OPL1000 A1 Module

Title		History	
Size A	Document Number	Rev V1.1	
Date:	Thursday, May 16, 2019	Sheet 1 of 2

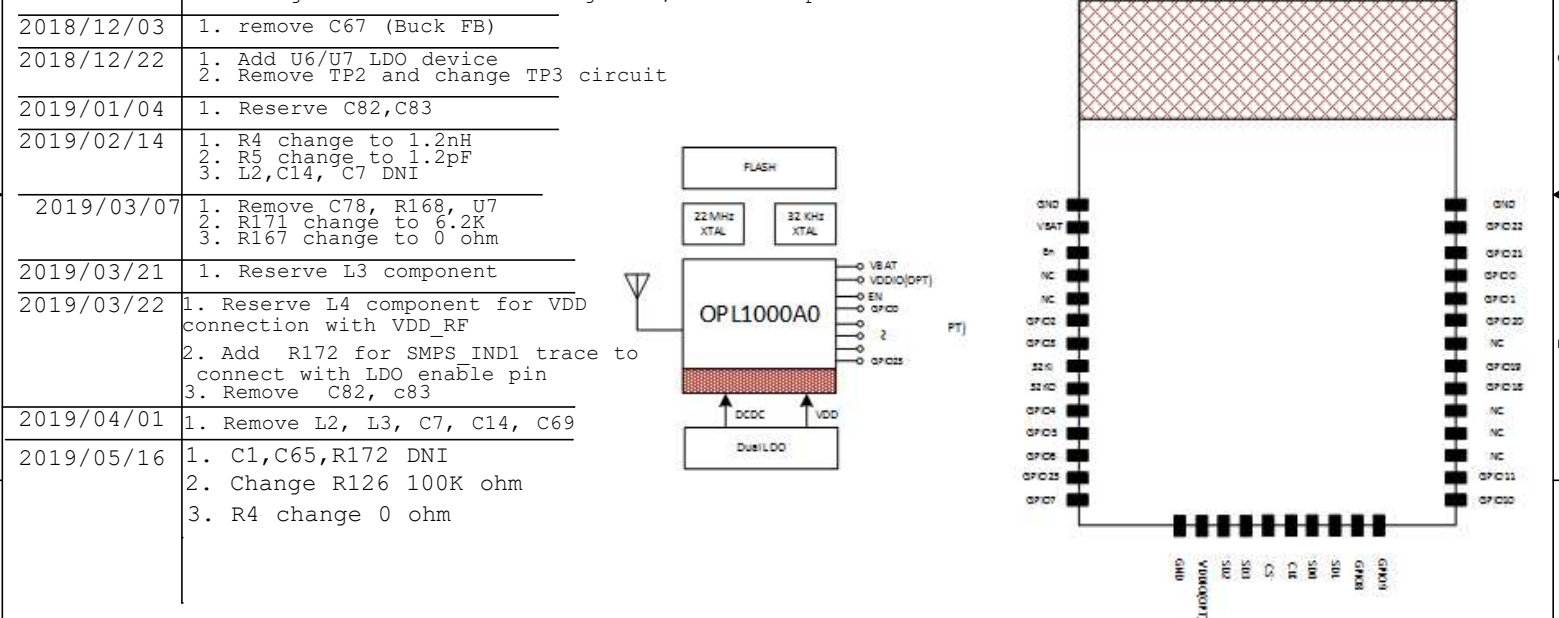
5	4	3	2	1
Date	Description			
2018/01/23	Initial			
2018/02/07	1. move out flash, 32K XTAL, C24			
2018/06/15	1. Change to A1 version			
2018/09/10	1. C26,C27 C28 DNI 2. Add C68, C69 L3 CN1 3. remove R3 R6 4. C14 change to 4.7uF 5. Add pi circuit on pin19,pin20			
2018/10/29	1. Add Flash, 32K XTAL, RST, EN circuit			
2018/11/08	1. remove C18,R82,R87,R88 (Flash part) 2. remove C20,C16, change C21 to 4,7uF 3. remove C18, change C72 to 10uF 4. remove D1,D2,C28,C26,C27 5. Change 32.768 XTAL 6. Change C70,C71 to 5.1pF			
2018/12/03	1. remove C67 (Buck FB)			
2018/12/22	1. Add U6/U7 LDO device 2. Remove TP2 and change TP3 circuit			
2019/01/04	1. Reserve C82,C83			
2019/02/14	1. R4 change to 1.2nH 2. R5 change to 1.2pF 3. L2,C14, C7 DNI			
2019/03/07	1. Remove C78, R168, U7 2. R171 change to 6.2K 3. R167 change to 0 ohm			
2019/03/21	1. Reserve L3 component			
2019/03/22	1. Reserve L4 component for VDD connection with VDD_RF 2. Add R172 for SMPS IND1 trace to connect with LDO enable pin 3. Remove C82, c83

2019/04/01	1. Remove L2, L3, C7, C14, C69			
2019/05/16	1. C1,C65,R172 DNI 2. Change R126 100K ohm 3. R4 change 0 ohm
